Re: Roadstone Dublin Ltd. – Waste Licence Application for Remediation of Unauthorised Landfill Sites at Blessington, Co. Wicklow (Licence Ref. No. 213-1)

Objection / Submission on the Proposed Decision dated 12th July 2005

**SUBMISSION ON PROPOSED DECISION OF
THE ENVIRONMENTAL PROTECTION AGENCY
TO REFUSE A WASTE LICENCE FOR
REMEDICATION OF UNAUTHORISED LANDFILL SITES
AT BLESSINGTON, CO. WICKLOW**

WASTE LICENCE APPLICATION No. 213-1

FIGURE 1

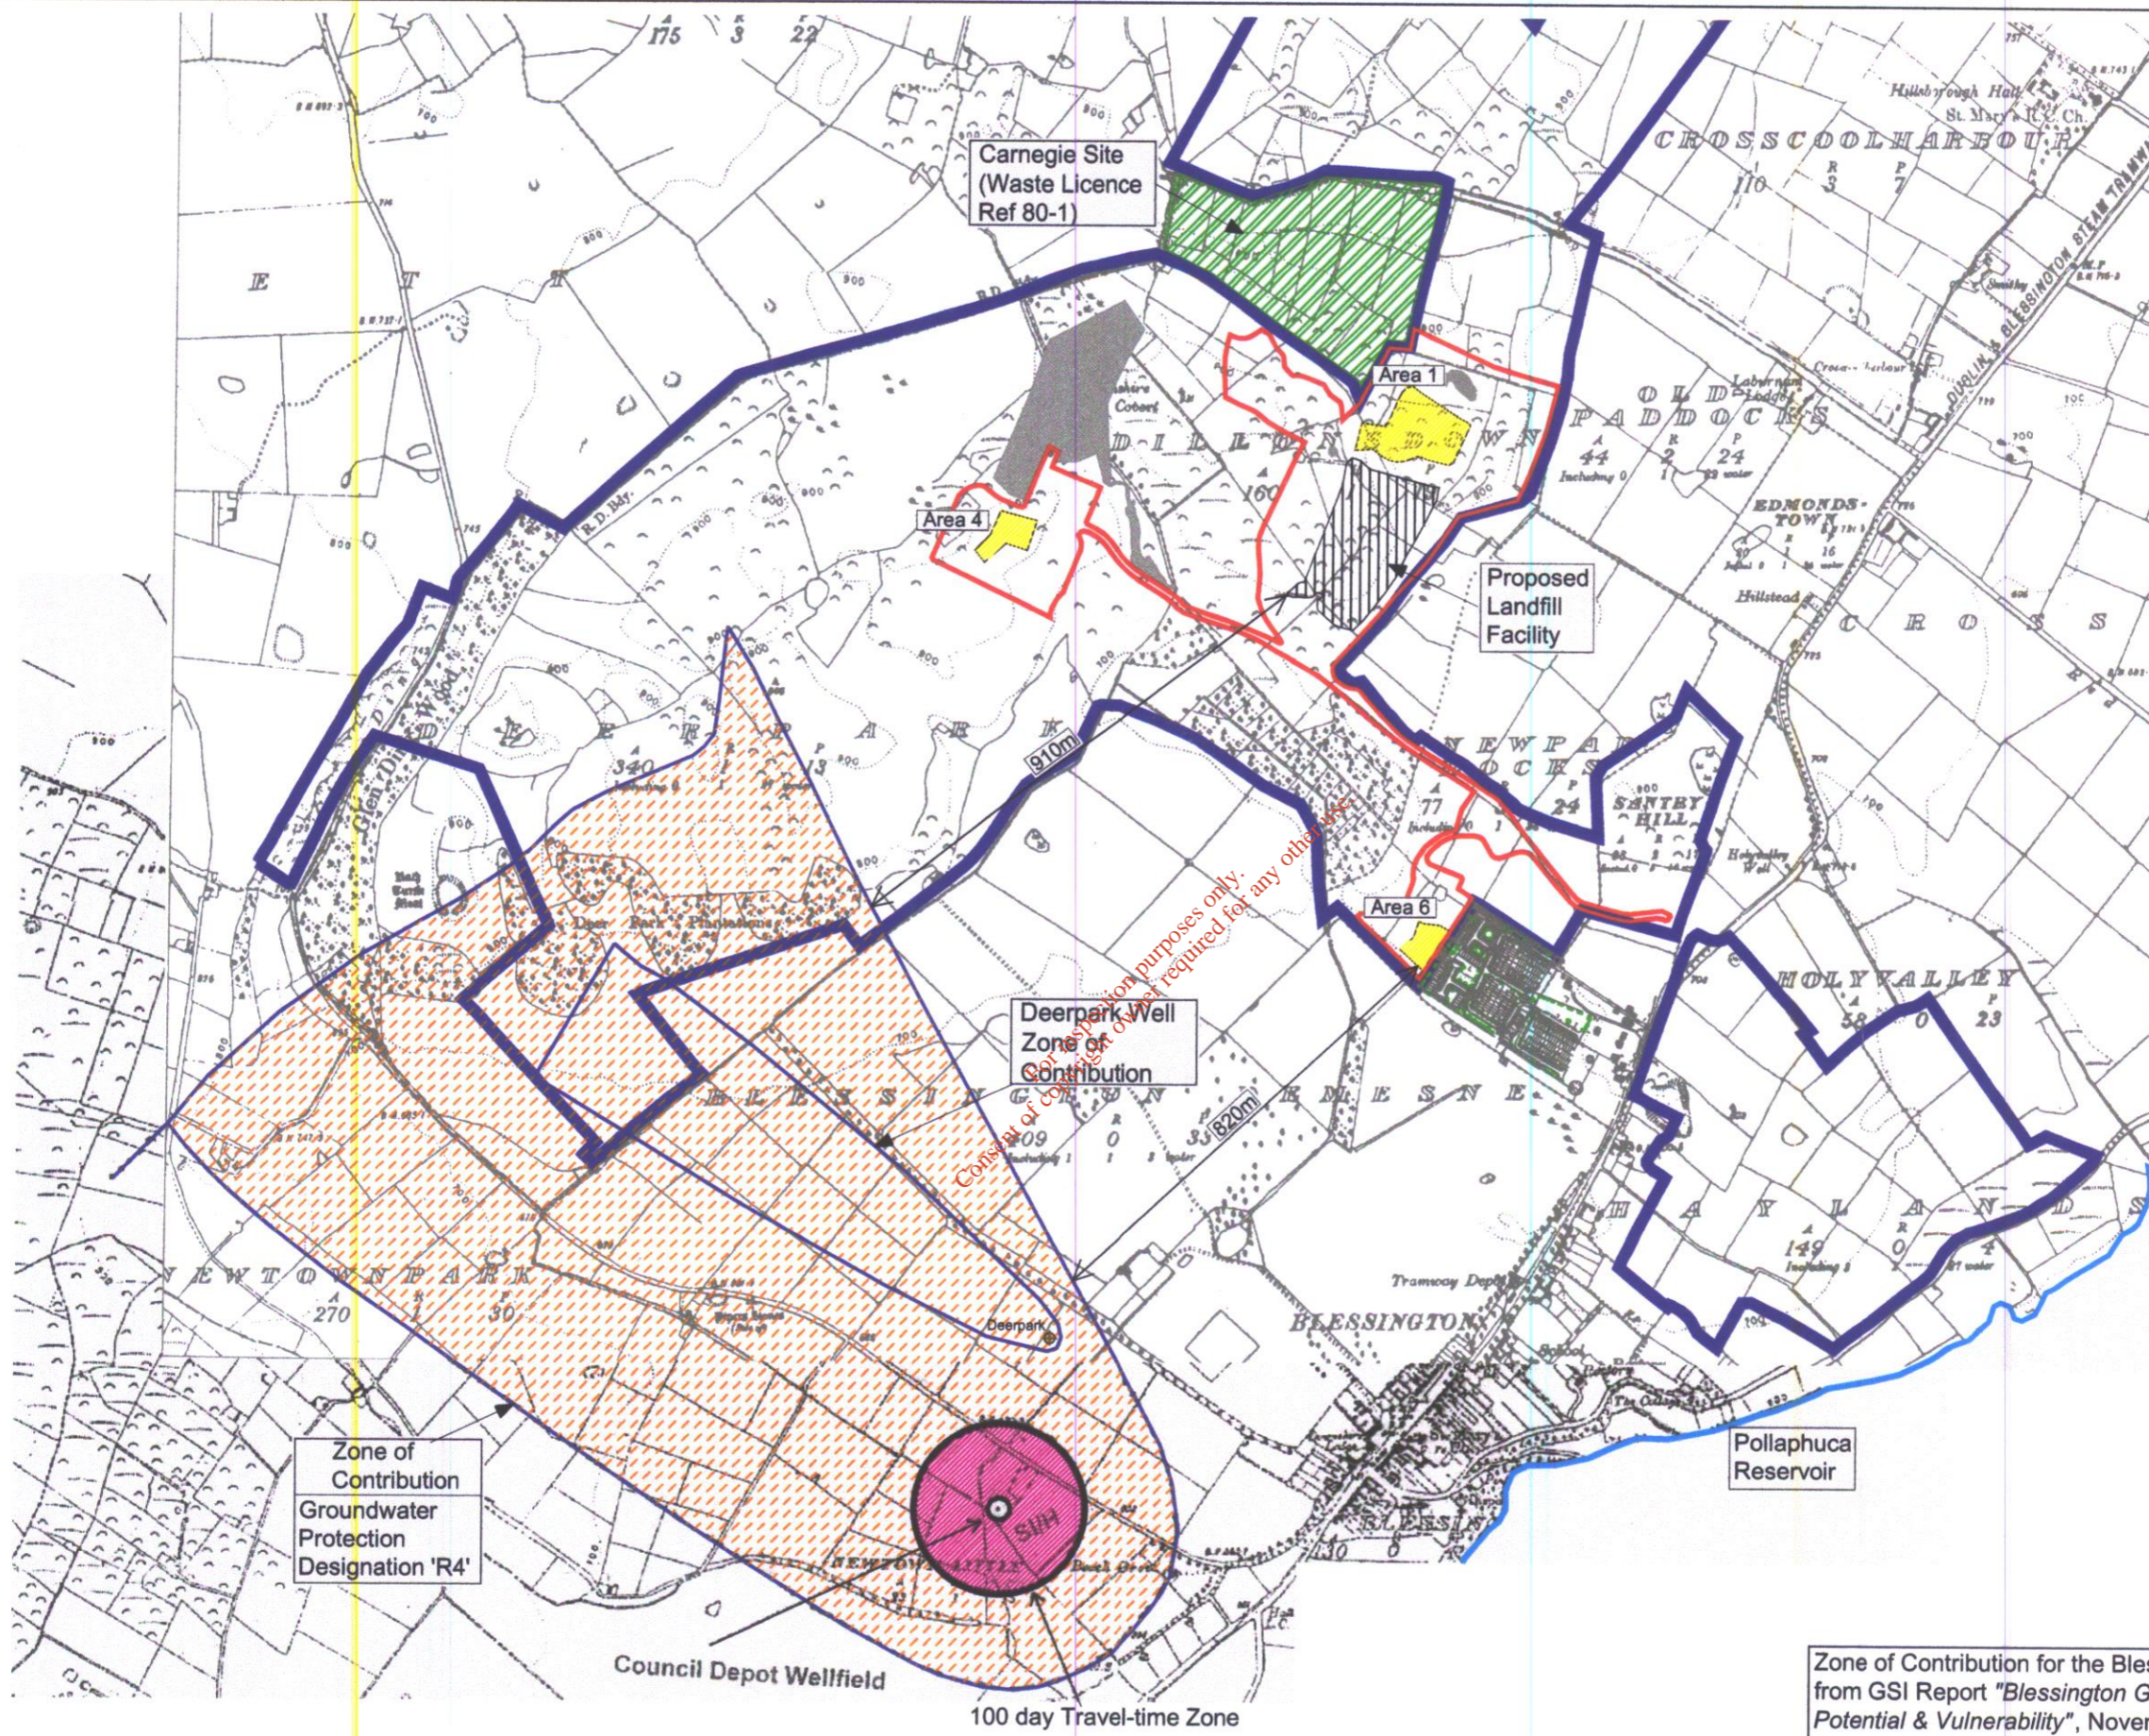
- B. The proposed landfill facility is not located within the "zone of contribution of the Blessington wellfield" :
- The zone of contribution for the Blessington Wellfield (ie. the likely boundary of the body of water that will ultimately flow into the wells), as defined by the Geological Survey of Ireland (GSI), at its closest point lies approximately 0.9km from the proposed landfill facility, refer to Figure 1.

- The zone of contribution for Local Authority wellfields, at its closest point, is in excess of 0.8km from the existing unauthorised landfill at Area 6 and in excess of 0.9km from the proposed residual engineered landfill facility sites (refer to Figure 1). **The zone of contribution does not extend beneath the unauthorised landfill sites or the proposed landfill facility.** On this basis, there is no realistic risk that groundwater from beneath the proposed landfill facility will reach and contaminate the Blessington Wellfield. Refer to the Mouchel Parkman report (August 2005) reproduced in Appendix B.
